# ELECTRIC/AIR SHIFT SYSTEM SOLENOID VALVE SUPPLEMENT

## POWER-MISER KIT NO. 48M81251

IN94-08 (Rev. 11-07) Printed in the U.S.A.  
© Muncie Power Products, Inc. 2007

### POWER-MISER VALVE PORTING DIAGRAM

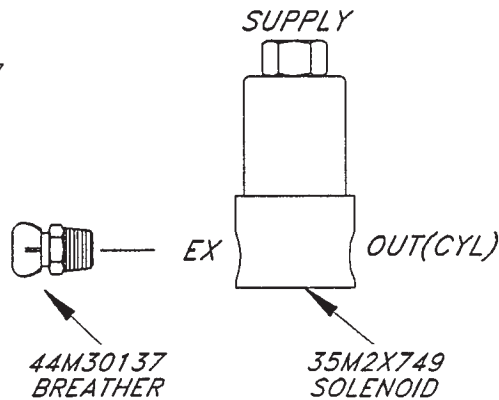
Solenoid No. 35M2X749 Replaces Solenoid No. 35M00310 and 35M062E1.

Note: Exhaust port requires Breather Part No. 44M30137 to be installed for added protection.

### POWR-PRO VALVE PORTING DIAGRAM

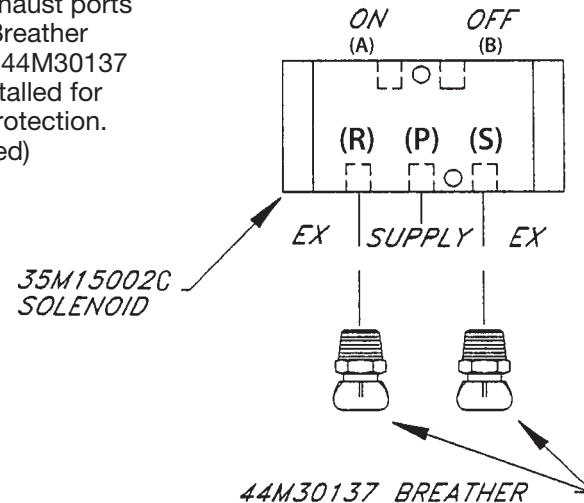
Solenoid No. 35M15002C Replaces Solenoid No. 35M00410.

Note: Exhaust ports require Breather Part No. 44M30137 to be installed for added protection. (2 required)
